ADDENDUM #2

June 1, 2018

Roof Renovation Project
Manchester Regional Academy
Manchester, CT
Reference #2017-031A

SHEET NO.
SKA1.1

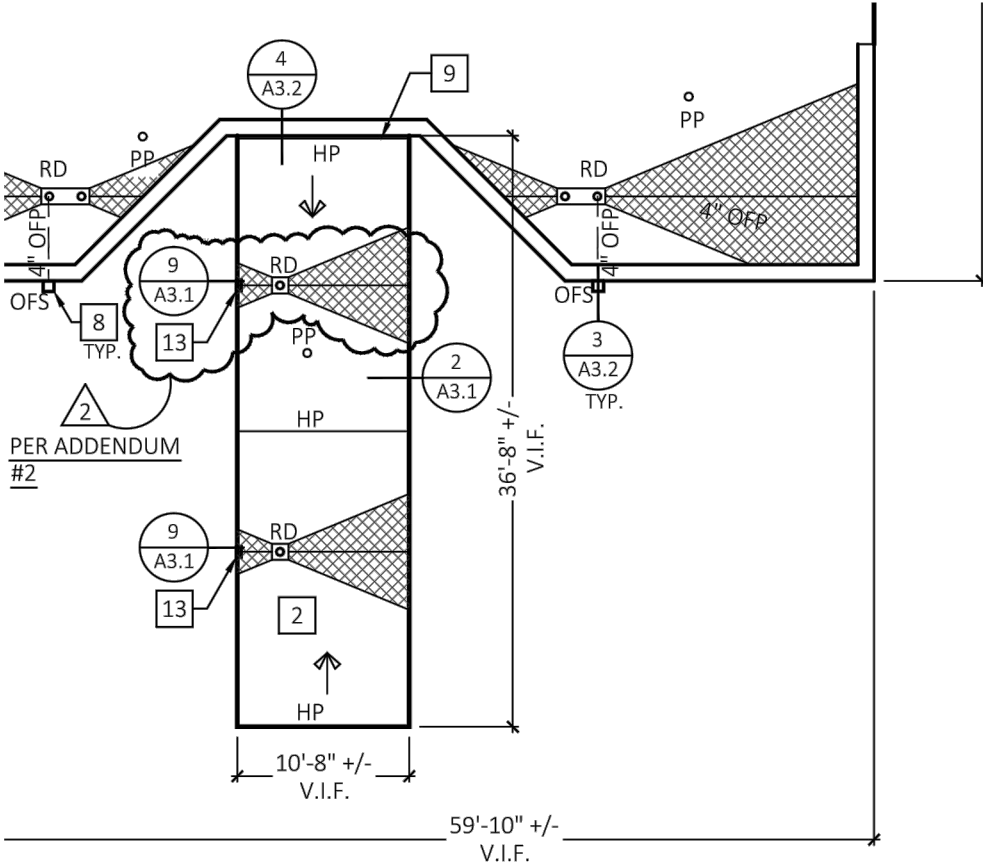
SKA1.1 – Clarification Sketch: Entrance Canopy Roof Drain

Remove existing roof drain at the location as shown on Sheet A1.1, Demolition Roof Plan.

Install new roof drain as shown on SKA1.1, Entrance Canopy Roof Drain.

New roof drain per Specification Section 221423 - Storm Drainage Piping Specialties, Part 2: Products, 2.1 Metal Roof Drains, B) Cast Iron, Primary Roof Drain.
